VALUE ENGINEERING STUDY

Project # STP00-0198-01(020) PI No. 132610-

SR60 Widening & Reconstruction in Murrayville
Hall County, Georgia

23 June 2011

R-22.0 Current Design Bark Camp Road Intersection

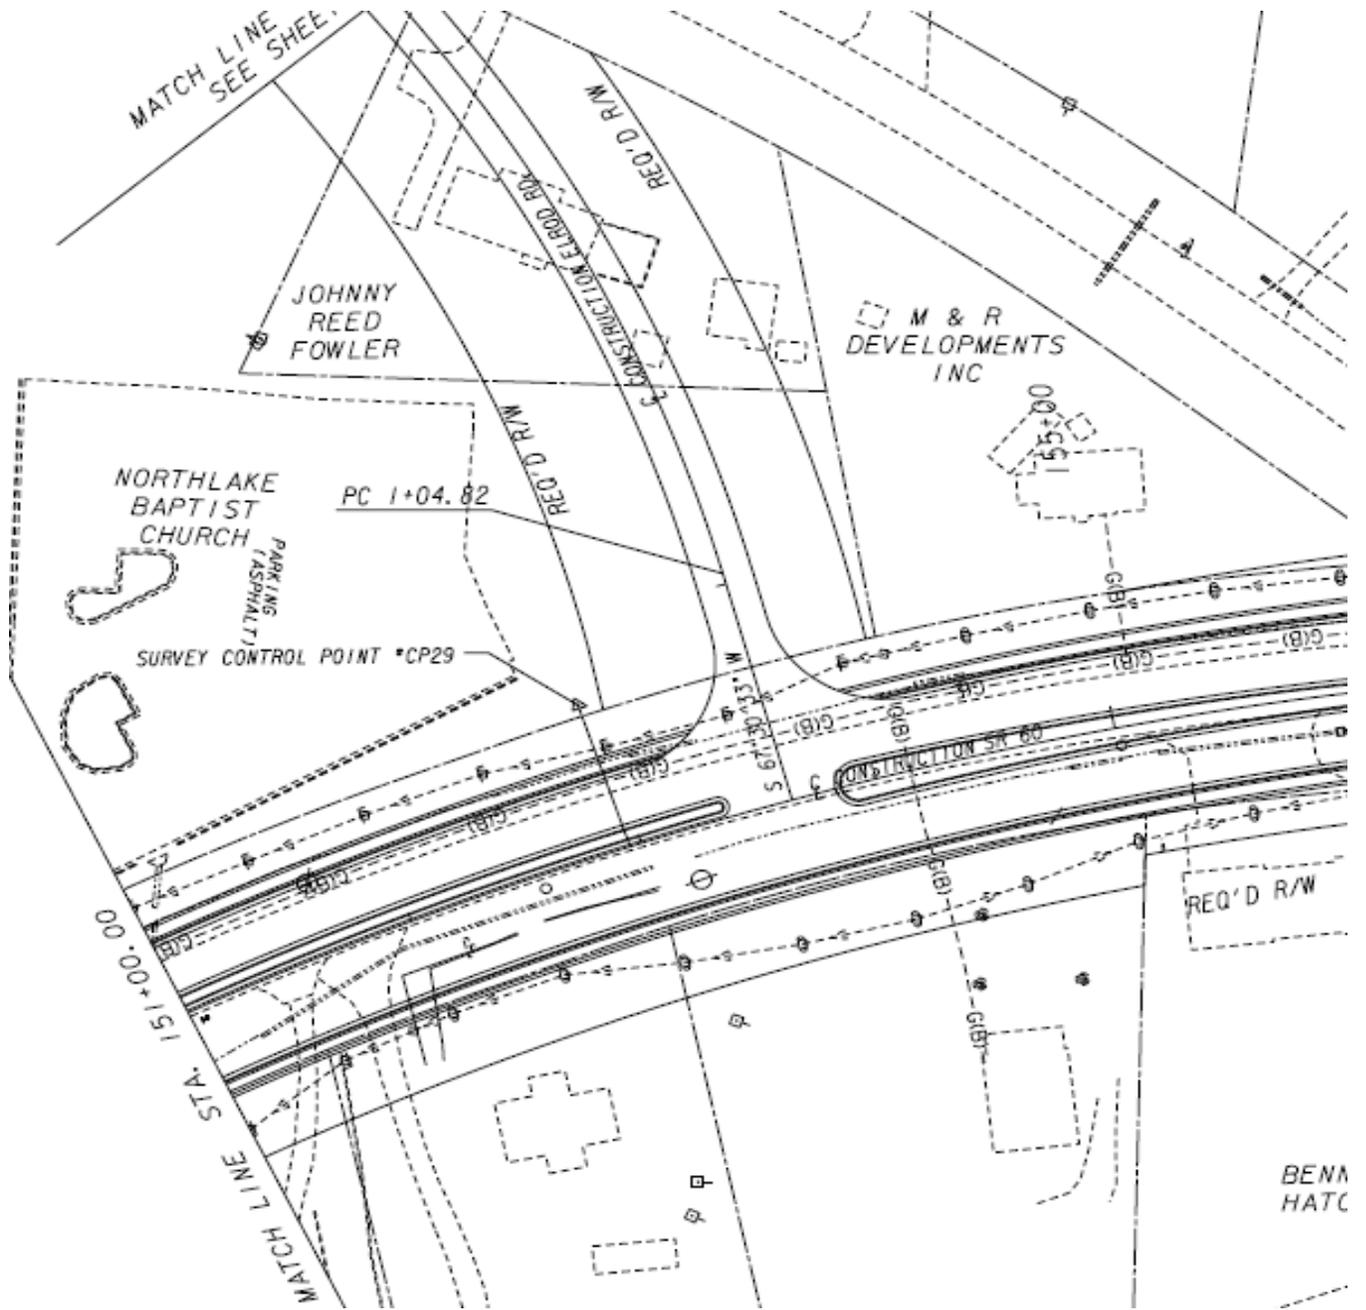
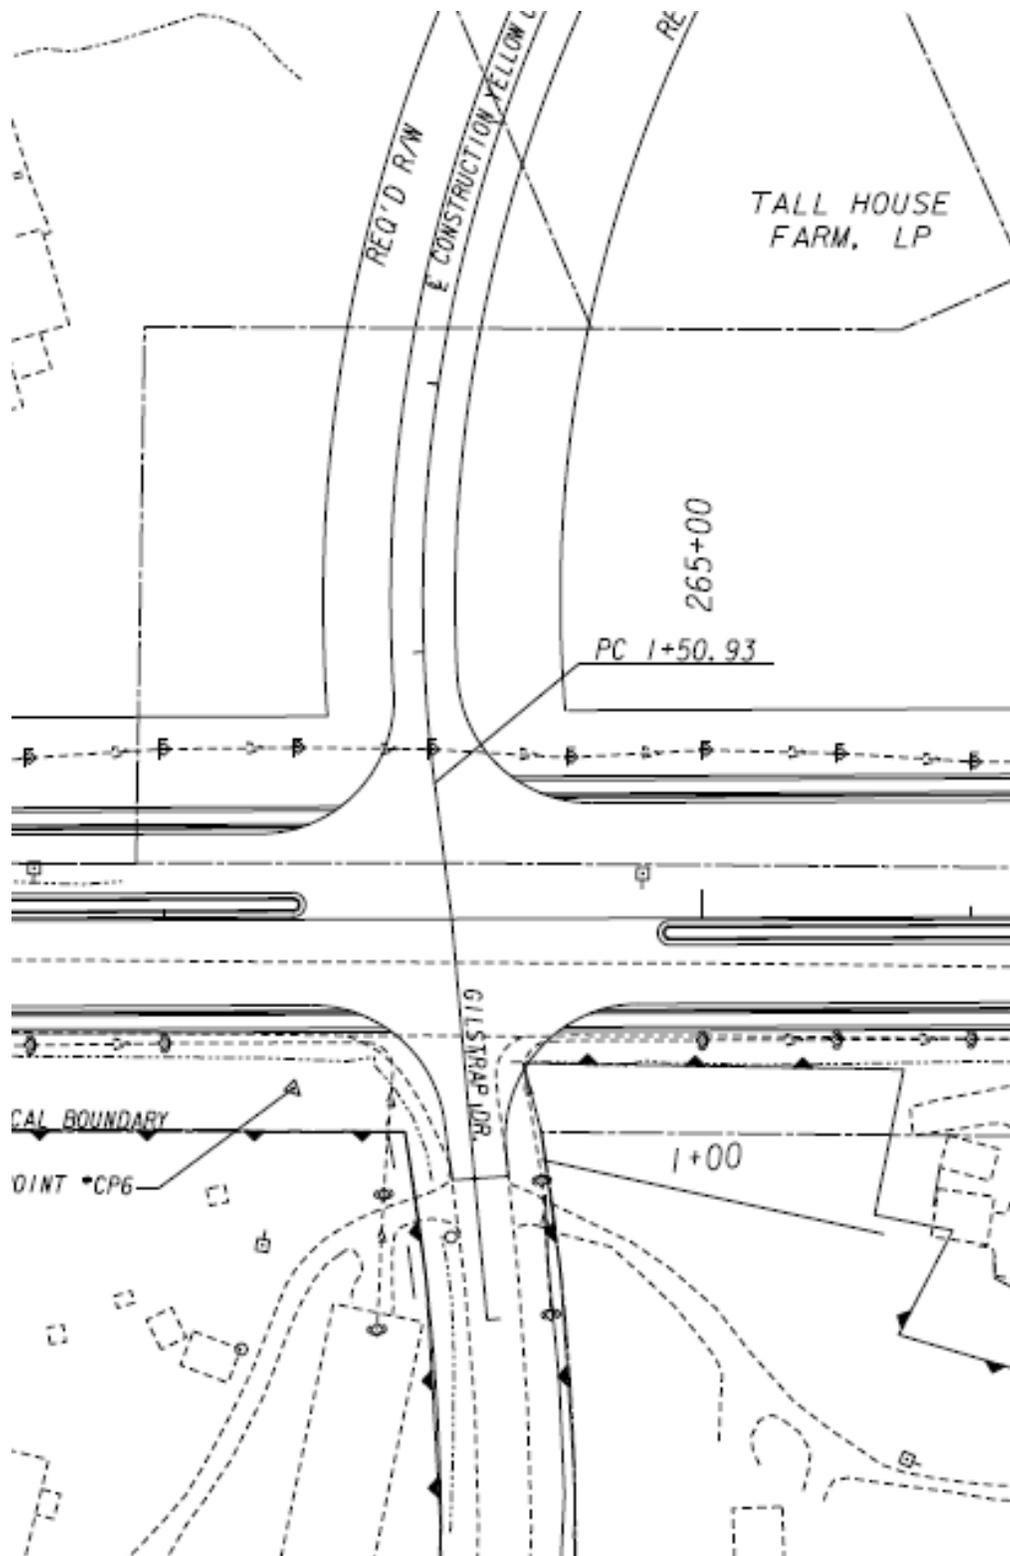
PROPOSED CHANGE: The proposed recommendation is to eliminate realignment of existing side roads Jerry Burress Rd., Wahoo Rd., Old Dahlonega Hwy, Kanady Rd., Hopewell Rd, Bark Camp Rd., Elrod Rd., Yellow Creek Rd.

R-23.0 Current Design Seminole Road Intersection

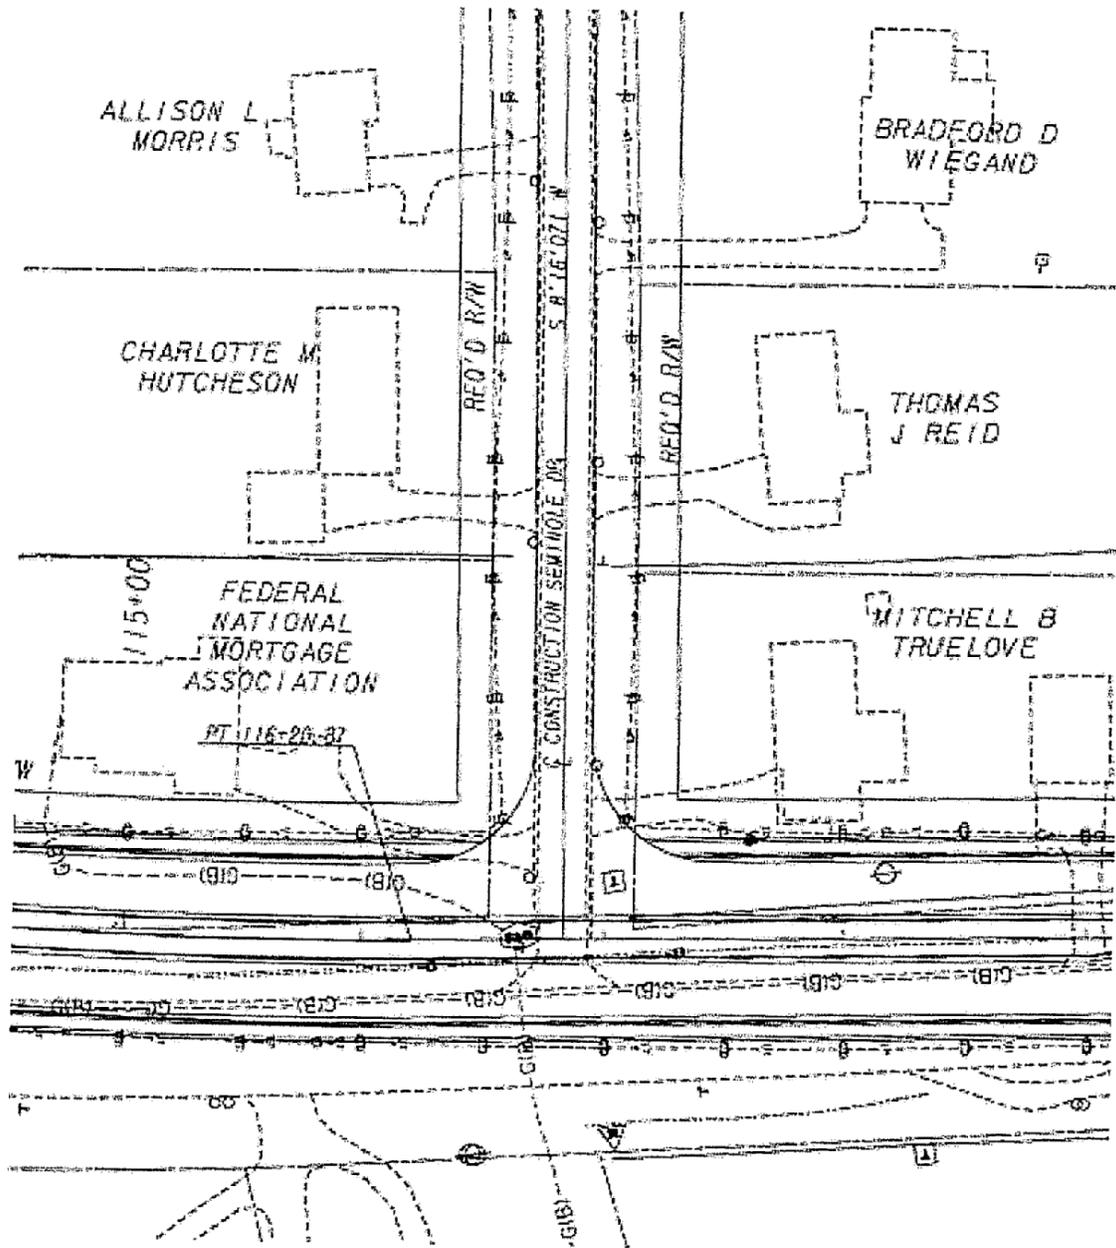
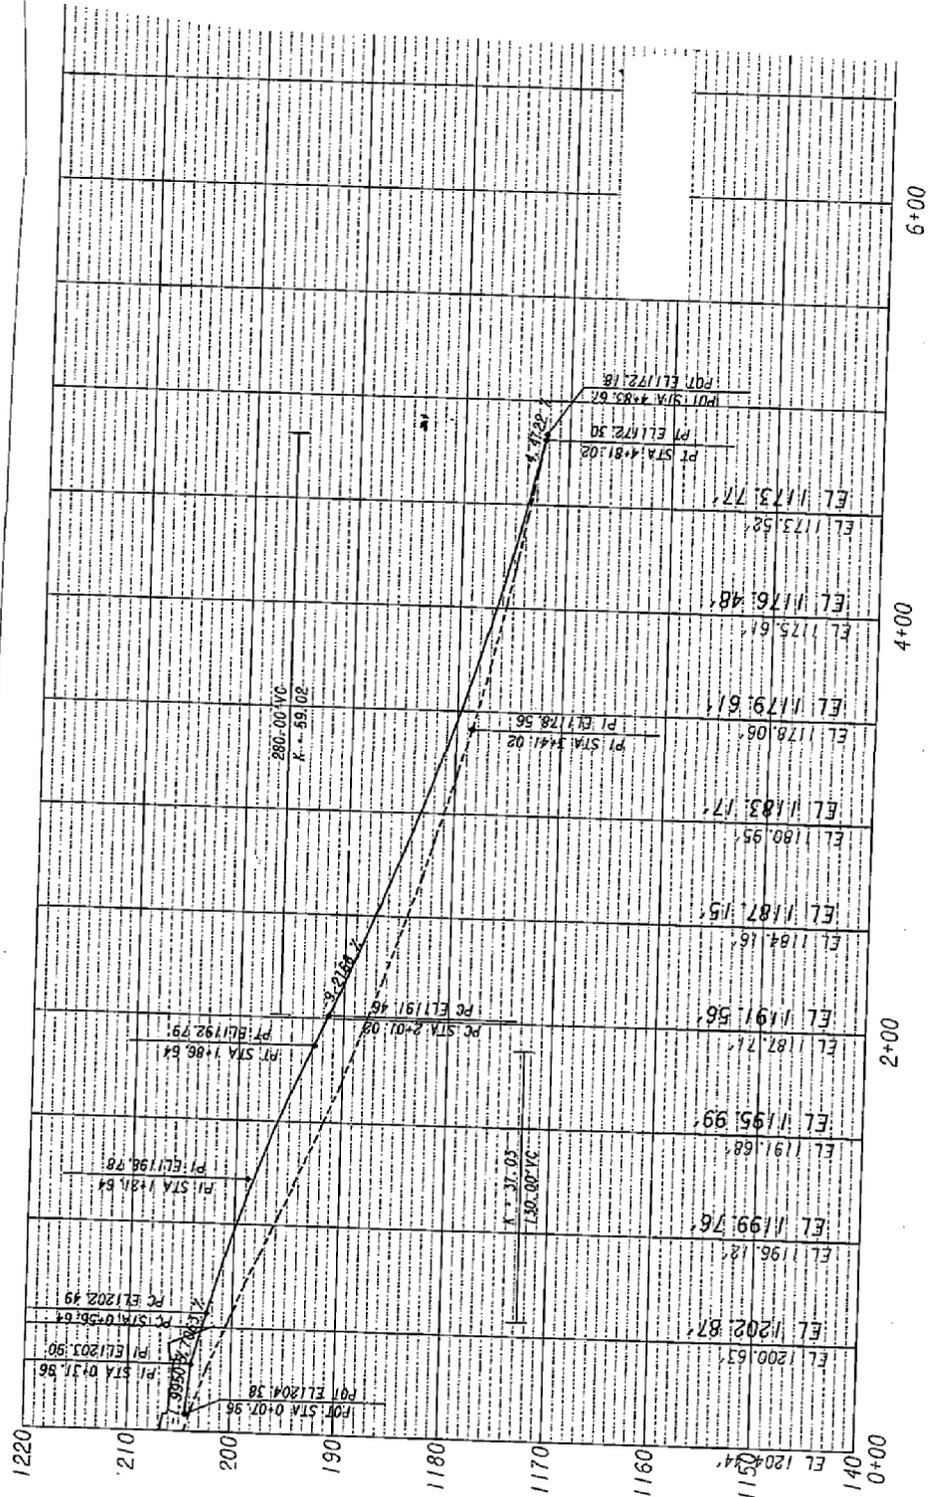
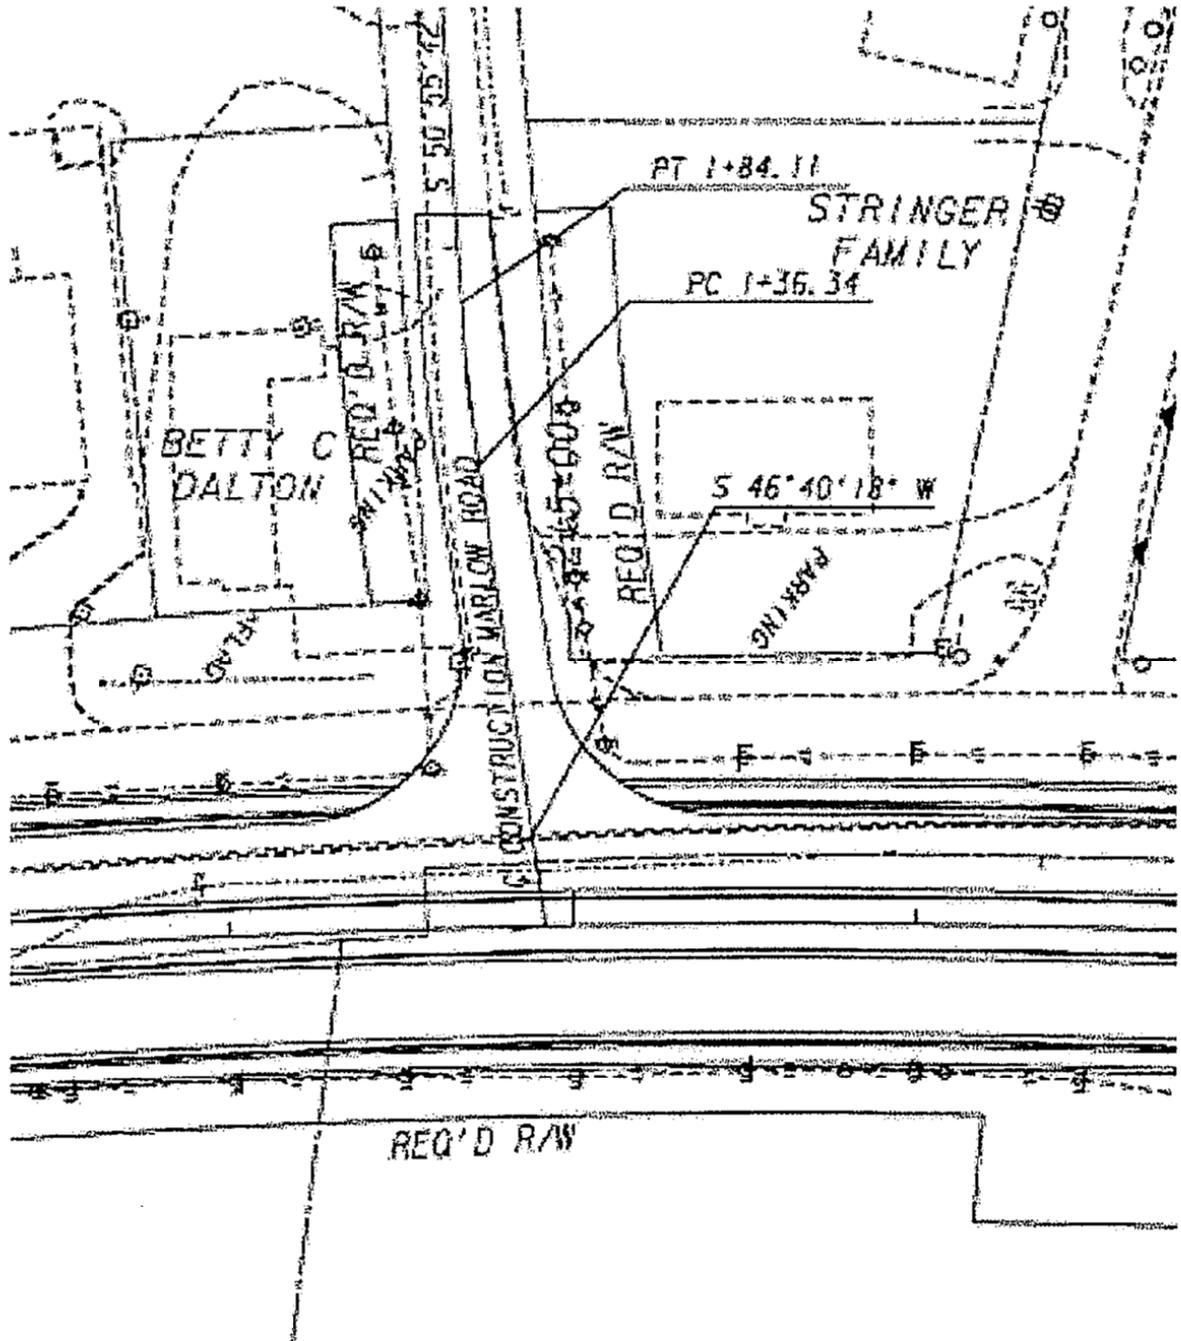
ORIGINAL DESIGN: The current concept design proposes to change profile on side roads to affect a minimum width ROW that will require relocations in some instances.

PROPOSED CHANGE: The proposed recommendation is to eliminate profile changes on Twin Oaks Lane, Marlow Road, Seminole Drive.
